To: Jim Cirello, RLA & Andrew Richards, PE
From: Pat O’Mahony, Associate Planner; 910-341-0189
CC: File;
Date: 12/13/2021
Re: Smile Straight Ortho TRC Rev. 1

Project Name: Smile Straight Orthodontics

Department: Engineering – Plan Review Section

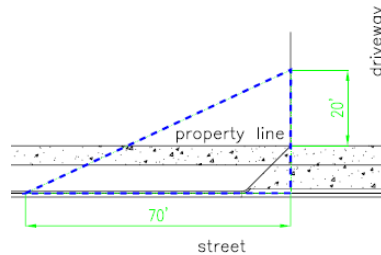
1. Show and apply the City's 20'x70' sight distance triangle at driveway as per an image below. [\[Sec.18-529\(c\) \(3\) CofW LDC\]](#) [\[Sec. 18-812 CofW LDC\]](#). [\[Sec. 18-667 Figure 18-667 CofW Updated LDC: Vision clearance\]](#) [\[Sec. 18-693 CofW Updated LDC\]](#).
